PLANNING TECHNICAL REVIEW COMMITTEE –AGENDA

1. 10:30 AM - 11:15 AM: Site Review for VC Dover Investment, LLC, Assessor's Map H, Lot 4-3-1, zoned Commercial, located at 30 Grapevine Drive. (Proposal is to build a new 15,040 sf (footprint), 4 story mixed use building next to the Hannaford's Grocery Store on Grapevine Drive.) (P22-72/SITE-2022-0017). *[This item was previously heard on November 17, 2022, January 5, 2023 & February 16, 2023]*

**Re: Dover Fields, Unit 2
Site plan and CUP**

Response to TRC Comments
Mixed Use Development – Dover Fields
30 Grapevine Drive Dover NH, 03820
Tax Map H-4-3

DRAINAGE PROFILE - SOUTH

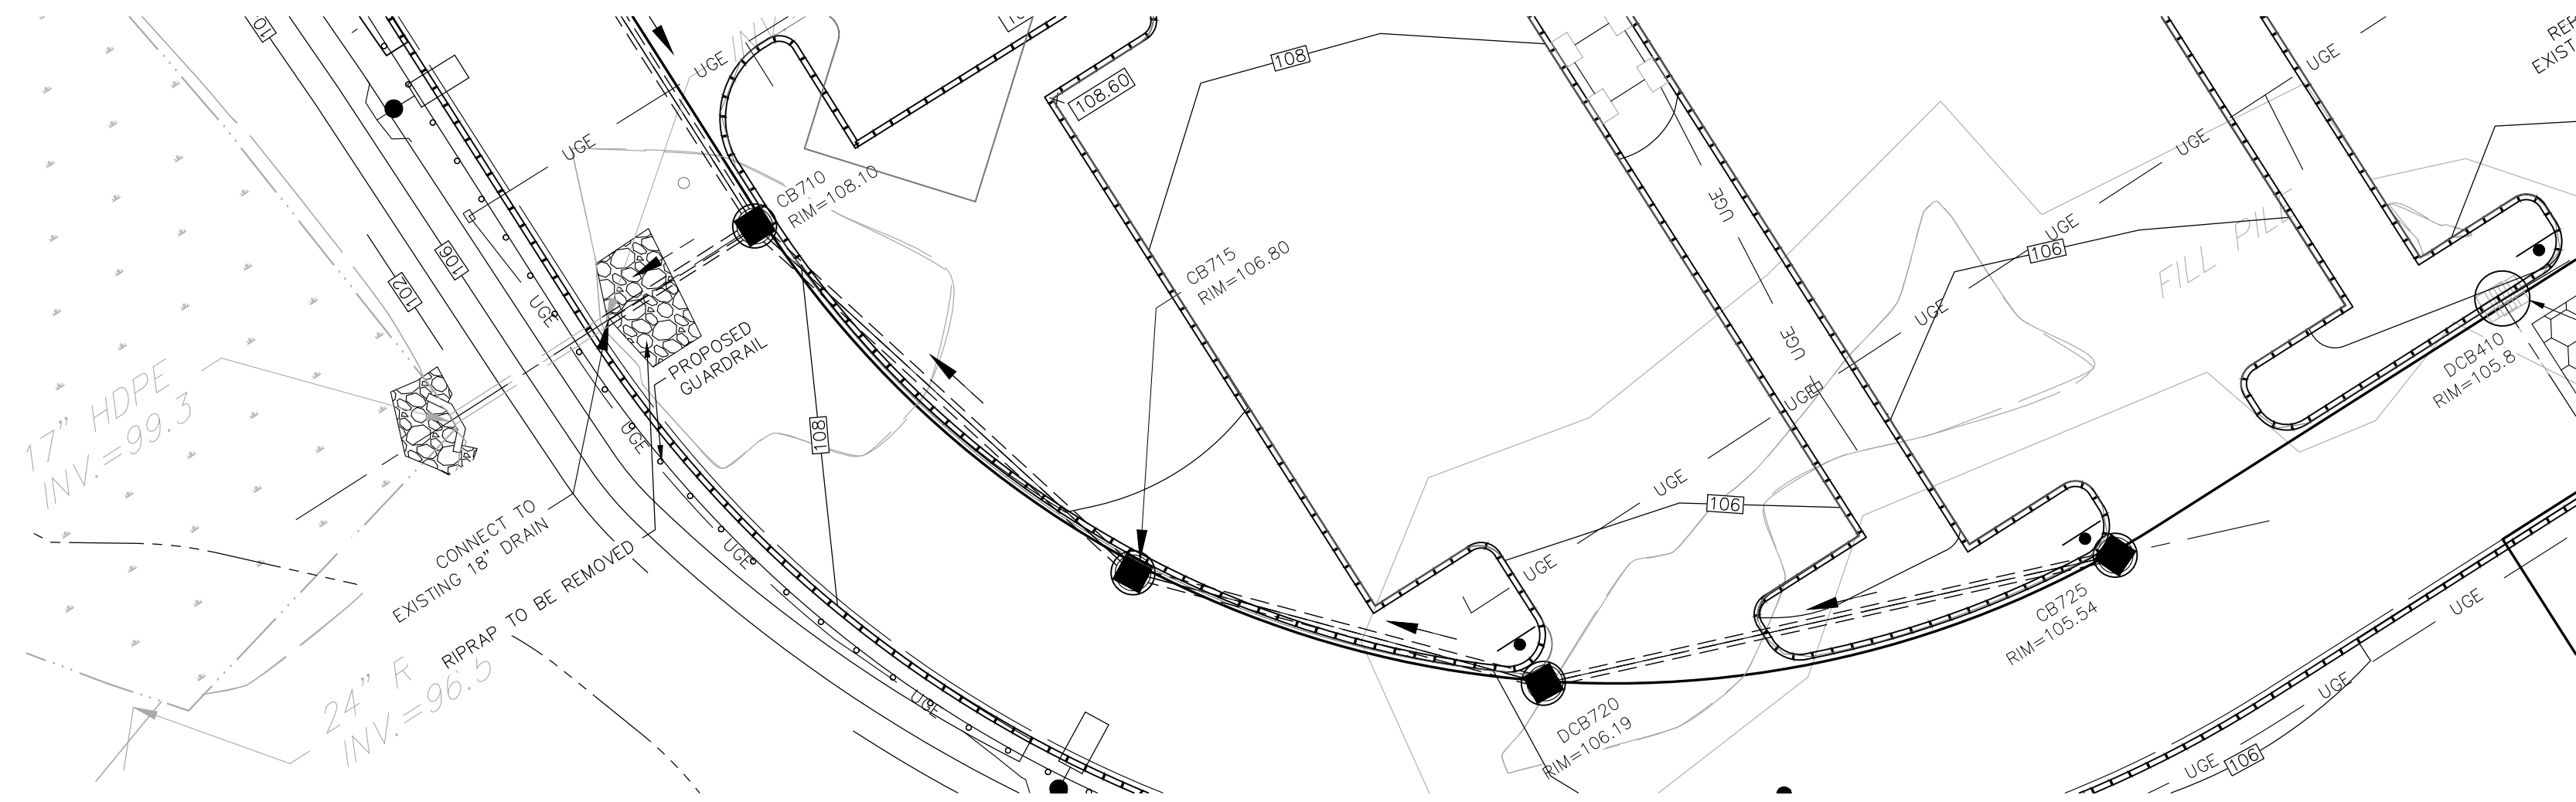
- Sheet 7 of 23: Recommend providing SMH where grease trap line ties into the 8-inch main.
- Sheet 8 of 23: Light Poles appear to be missing from the plan. Verify poles will not conflict with landscaping.

ROOF DRIP EDGE

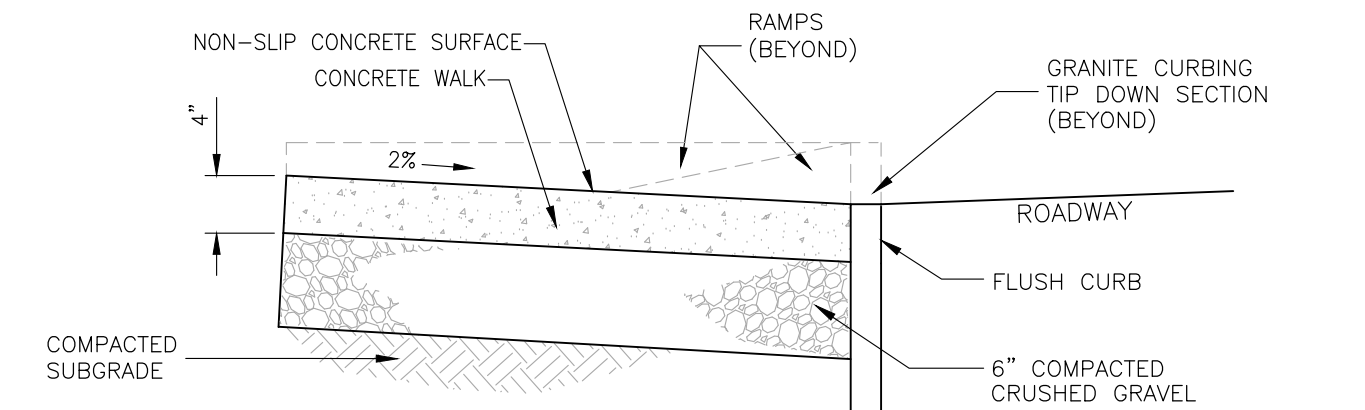
- General Comment: Provide stone drip edge detail.
- Sheet 15 of 23: Note 6 states that bedding of sewer shall be on 4-inches of crushed stone. Please revised dimension to reflect city of dover standard shown on the prior page.

CONCRETE WHEELSTOP

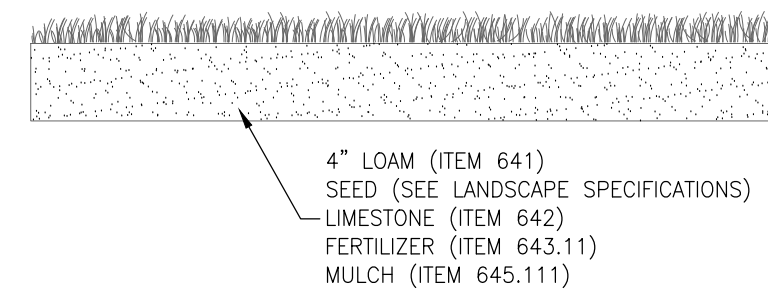
- General Comment: Verify slope and invert of existing sewer stubs prior to submitting wastewater connection permit to City for review and approval.
- General Comment: Provide a detail for the wheel stop that indicates material and installation method.
